# CITY COUNCIL AGENDA REPORT

**SUBJECT:** **REVIEW OF PLANNING APPLICATION PA-09-03**
**2172 MYRAN DRIVE**

**DATE:** **MARCH 26, 2009**

**FROM:** **DEVELOPMENT SERVICES DEPARTMENT**

SITE PLAN

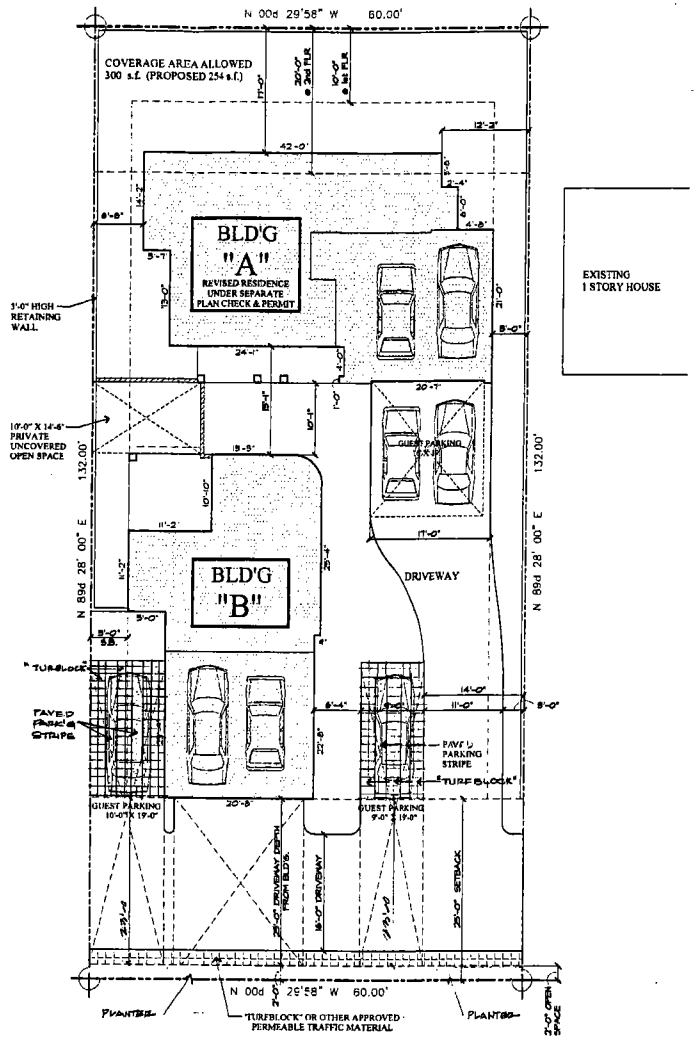
14. Applicant shall provide a new paved driveway surface within the private easement, extending from the subject property to Victoria Street, minimum 16 feet in width, subject to approval by the Planning Division.

15. The paving specified in condition of approval number 14 shall extend to the northerly end of the property line, to include the existing turn-around.

Brad Smith, architect, agreed to all the conditions and said there was a sewer lateral for all four parcels. He said he is willing to shift Building "B" to the right to meet the average 10-foot setback on the second floor.

LEFT SIDE ELEVATION

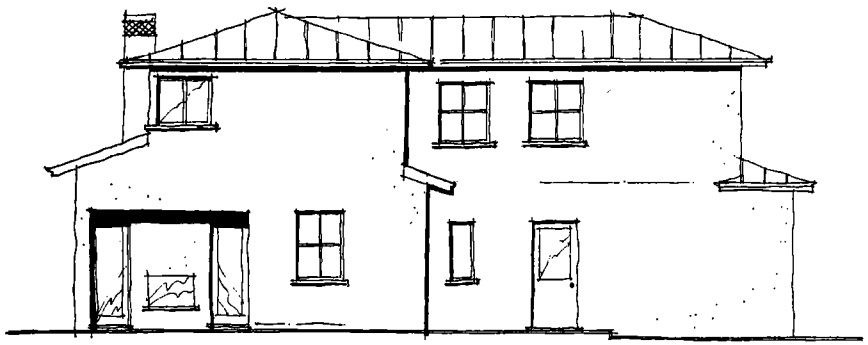
12. Bedroom windows on the north (left side) elevation for Building B shall be limited to small and/or high windows to minimize visibility into the abutting yards. Every effort shall be made to maintain the privacy of abutting property owners.
